Bombardier Recreational Products

ESSENTIAL SERVICE LITERATURE

Bulletin Set (2006 to 2010), P/N 5008798

BULLETIN SET (2006 TO 2010)

Date: June 2, 2008**No.** 2008-01(P)**MODELS:** All**SUBJECT:** *I-Command™* and *NMEA 2000†*
Network ConnectorsDear *Evinrude®/Johnson®* Dealers:

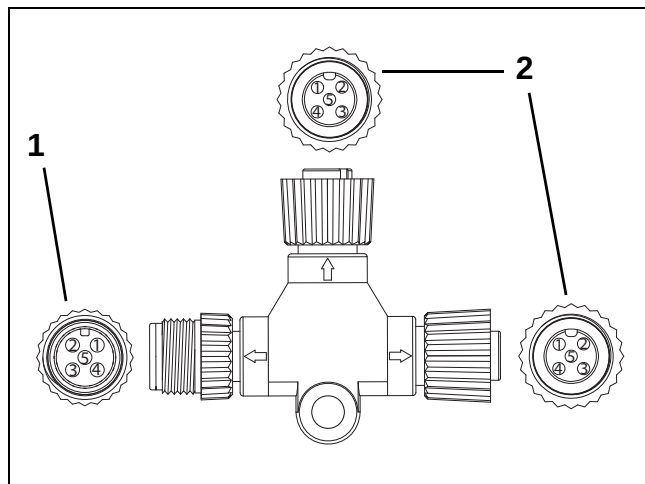
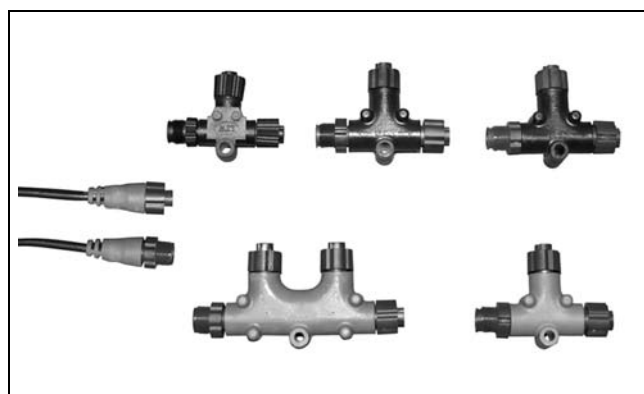
This bulletin is to inform dealers of the differences in *I-Command* compatible DeviceNet-style connectors.

Use the *I-Command Product Guide*, P/N 764677, or a current *Accessories Parts Catalog* (2008 or newer) to look up part numbers for *I-Command* network connectors.

No. 2006-05(S)

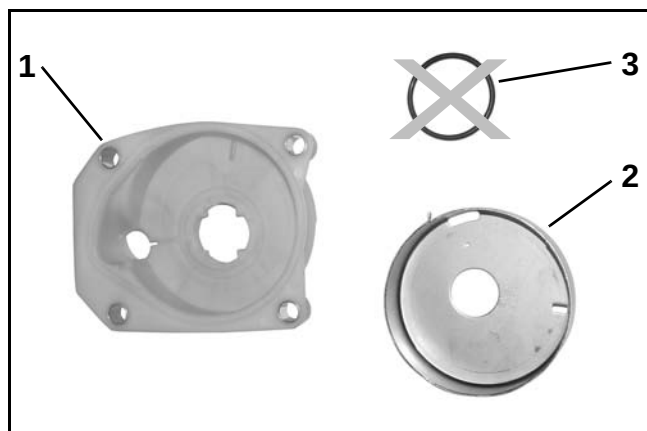
This communication is to provide information related to product changes on Evinrude E-TEC 40–60 HP outboards.

A change to water pump assembly was released to production. The O-ring positioned between the impeller liner and impeller housing is not required, and has been removed from the water pump assembly.

This change improves water pump performance and the water pump's ability to purge air from the pump housing. Outboards run at higher transom settings and in severely aerated water conditions will benefit most from this change.

Intermittent high speed overheating (accompanied by an overheat alarm) may be an indication of a damaged water pump. Aerated water entering the pump at high speeds can cause impeller damage, evidenced by rubber transfer to the top of the water pump liner. Replace the damaged water pump, assembling the **new** water pump without the O-ring between the liner and the housing.

IDENTIFICATION PROCEDURE

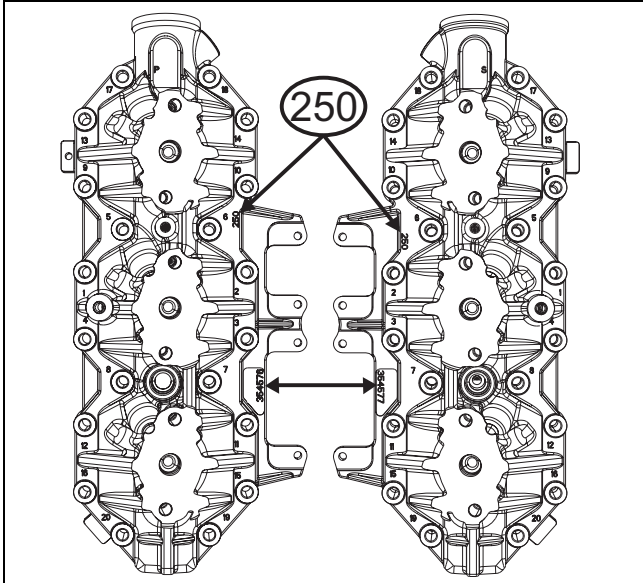
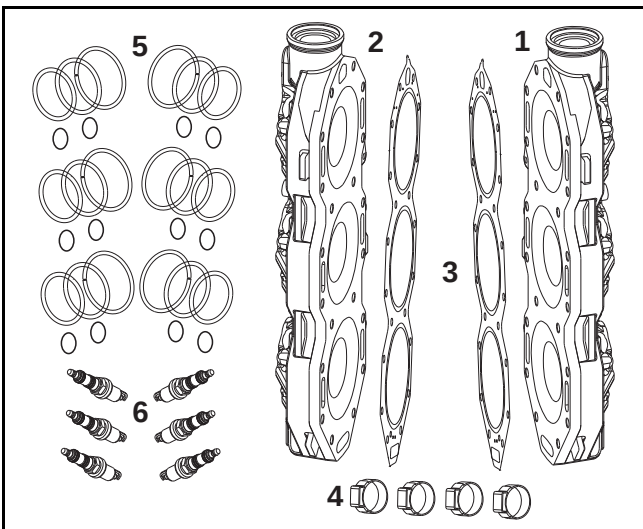
Outboards with replacement cylinder heads can be easily identified. The engine cylinder heads have identification numbers in the castings. This kit provides port cylinder head, P/N 354576, and starboard cylinder head, P/N 354577. Both cylinder heads have identification number 250 in the casting.

CYLINDER HEAD KIT, P/N 5008247
